REMARKS

In the Office Action mailed August 31, 2006, firstly, Examiner objected to the drawings indicating that Figure 10 required correction to substitute --13-13-- for "B-B", and noting that reference numerals 46 and 18 were missing from the drawings. The drawings have now been amended to correct those deficiencies.

1/15

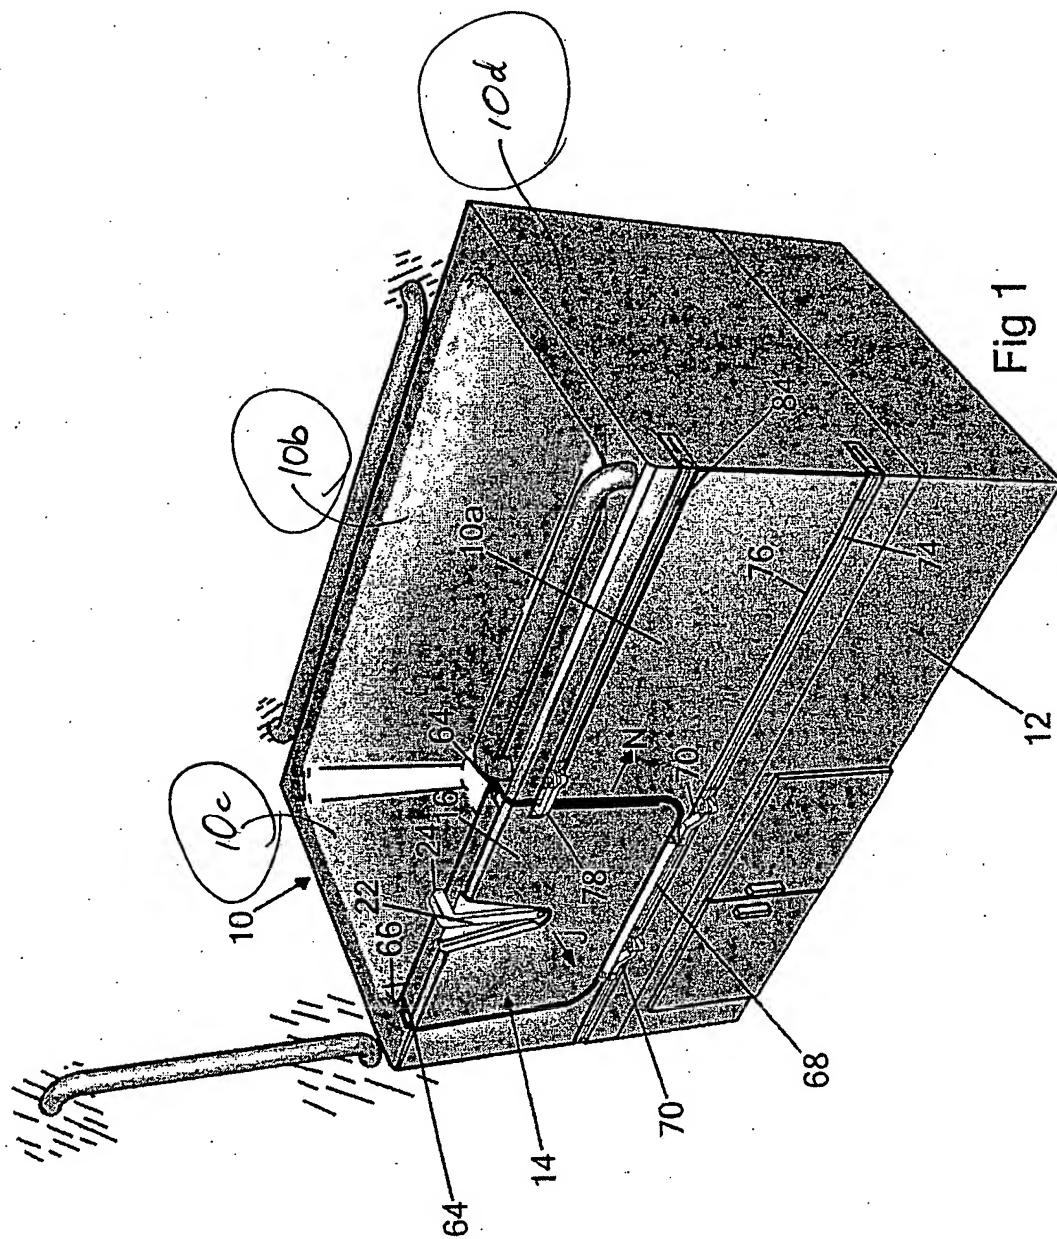
Applicant submits proposed changes to Figures 1, 3, 4 and 10, shown as circled. Applicant requests that the Examiner consider the changes. A complete set of drawings is enclosed as required.
